# UNITED STATES PATENT AND TRADEMARK OFFICE

APPLICATION NO.	FILING DATE	FIRST NAMED INVENTOR	ATTORNEY DOCKET NO.	CONFIRMATION NO.
09/987,982	11/16/2001	Chikashi Satou	110811	8001

**Office Action Summary**

## **DETAILED ACTION**

FIG. 2  
RELATED ART

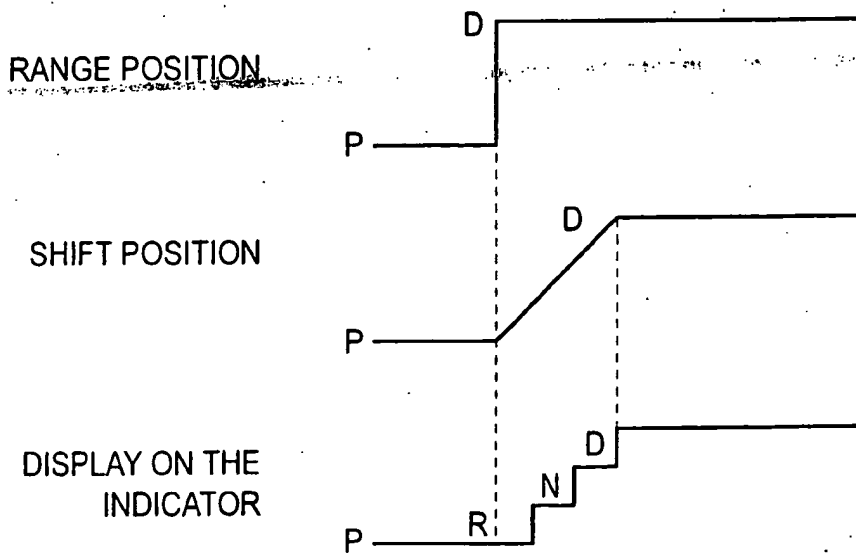
1. Figure 2 should be designated by a legend such as --Prior Art-- because only that which is old is illustrated. See MPEP § 608.02(g). Corrected drawings in compliance with 37 CFR 1.121(d) are required in reply to the Office action to avoid abandonment of the application. The replacement sheet(s) should be labeled "Replacement Sheet" in the page header (as per 37 CFR 1.121(d)) so as not to obstruct any portion of the drawing figures. If the changes are not accepted by the examiner, the applicant will be notified and informed of any required corrective action in the next Office action. The objection to the drawings will not be held in abeyance.
2. The proposed drawing correction of figure 2 was received on 4/25/05. This correction is not approved since the term "related" is not synonymous with "prior."

NOT  
approved  
XLN 7/11/05
